VALUE ENGINEERING CHANGE PROPOSAL
MISSOURI DEPARTMENT OF TRANSPORTATION

Conceptual Proposal Final Proposal Date 11/15/2011
Contract ID 111118-C04 Job No. J4P1138
County Johnson Original Bid Cost \$10,126,672.34
Contractor Emery Sapp & Sons, Inc. By Matthew Oesch
Designed By Matthew Oesch Phone 573-489-9216
VECP# 12-22 (to be completed by C.O.) VECP or PDVECP

SUBJECT: Route 13, Johnson County
From Rte. OO/V to Veterans Road Extension
Warrensburg East Loop Project North of US 50
Job. No. J4P1138
Request for Environmental Studies-Contractor Value Engineering Proposal

TO: Perry Allen – KC DCME
CC: File
FROM: Brian K. Iles – Resident Engineer
DATE: March 19, 2012
SUBJECT: VE Concept Proposal No. 1
Job No. J4P1138 (Contract ID 111118-C04)
Route 13, Johnson County

Also attached are J4P1138 plan sheets 26 and 31 showing the proposed VE new slope limits along with the proposed VE 350 foot long 48" pipe.

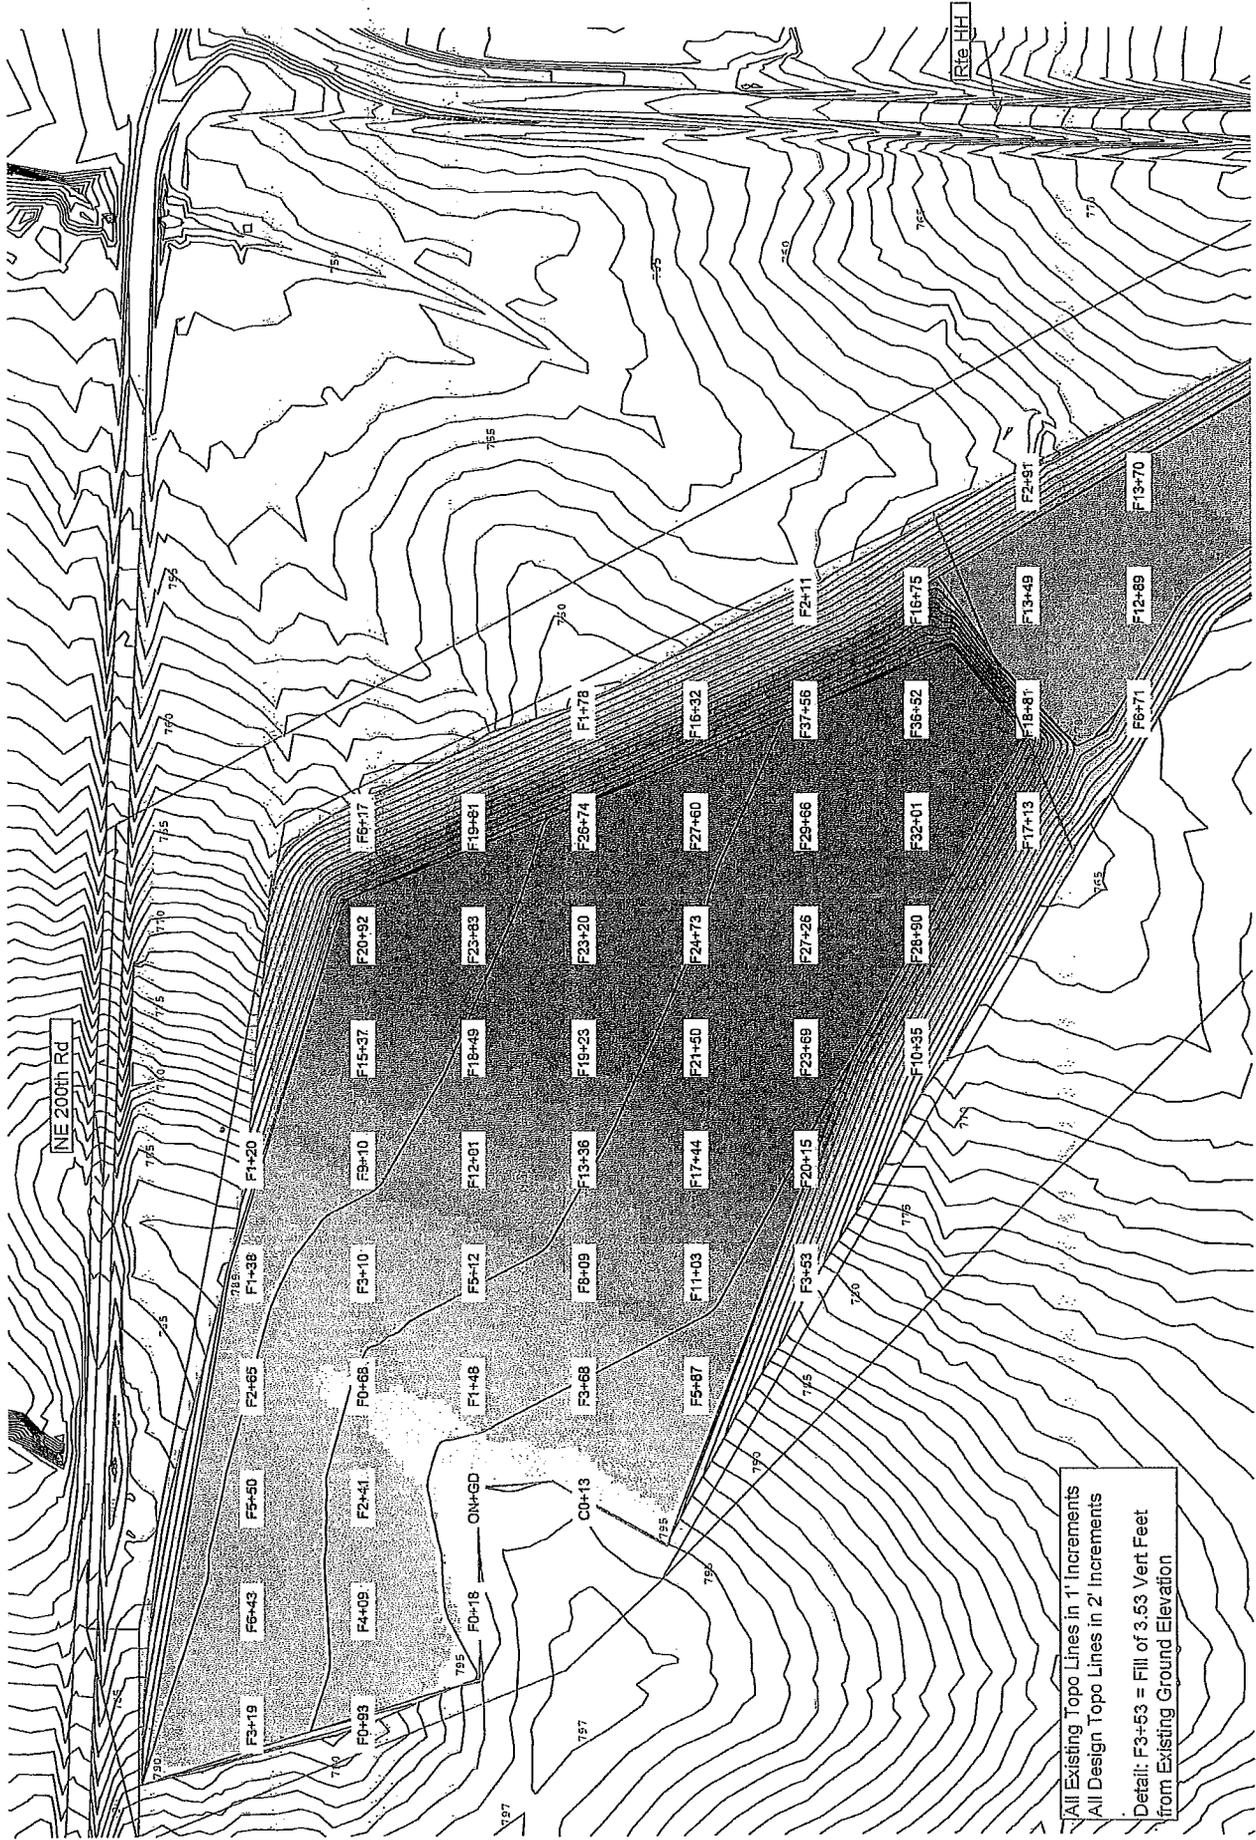
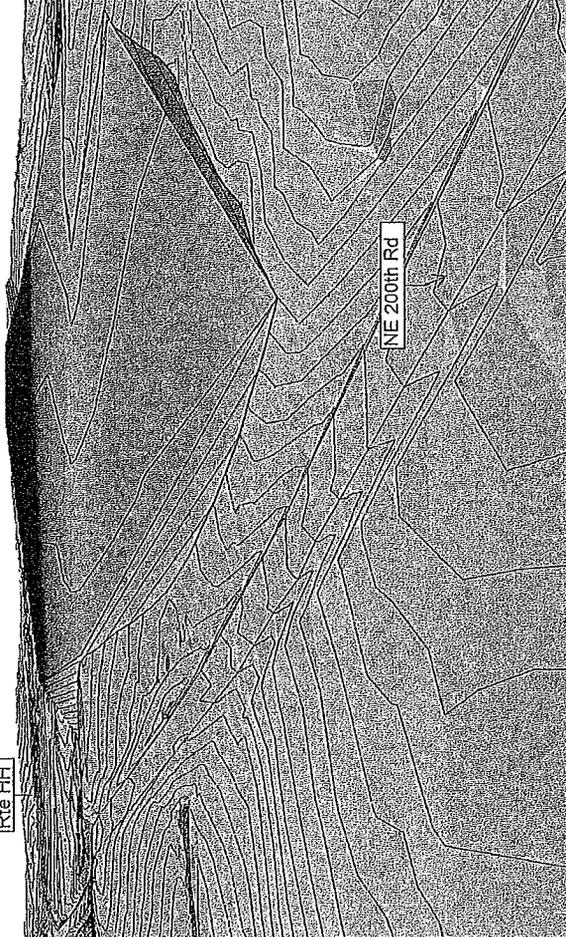
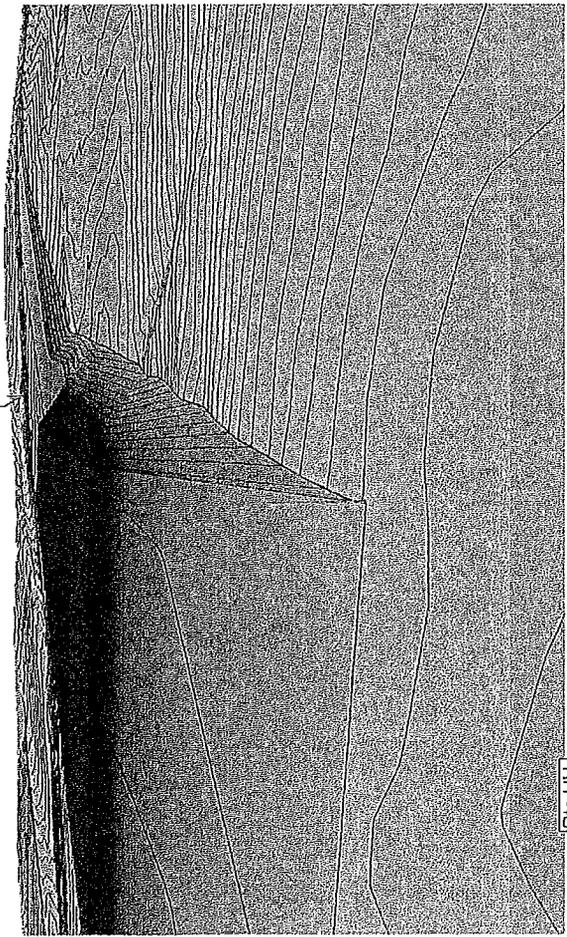
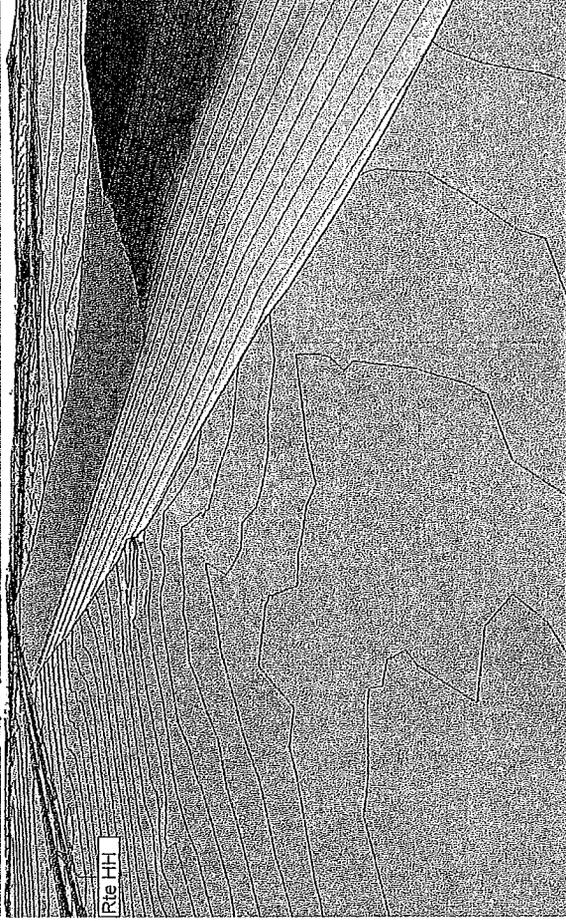
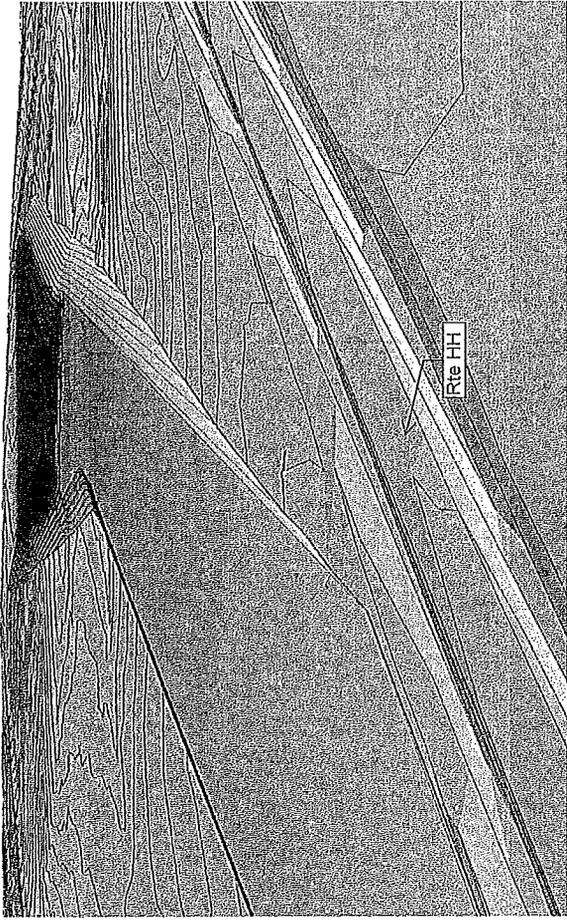
The contractor's proposed VE involves placing and compacting the project's excess earthwork (388,000 cubic yards of uncompacted excess) on existing R/W at the southwest quadrant of the intersection of new Rte. 13 with Route HH / County Road 200. This area that the contractor wants to place the excess earthwork on is for the future diamond interchange. If the contractor gets approval for this VE, they will place their concrete batch plant on the flat portion of the excess mound of dirt and use the severed portion of Rte. HH as the truck entrance to the concrete batch plant.

This proposal will require installation of 48-inch pipe that is 350-feet long beneath the waste area. The proposal has several options for this pipe type. Due to the height of fill above the pipe MoDOT Design has indicated that Pipe Option No. 2 will suffice but Pipe Option No. 1 may need to be used if the standard fill heights are exceeded. I recommend we use Pipe Option No. 2 because the pipe is outside the roadbed. The pipe will be under the roadbed for the future expansion, but the fill should be cut down to within the standard fill height at that time.

I recommend approval of this Value Engineering Concept Proposal. As previously stated, this recommendation comes with the use of Pipe Option No. 2. Therefore, the proposed savings is \$104,872.80 (\$162, 852.80-\$57,980).
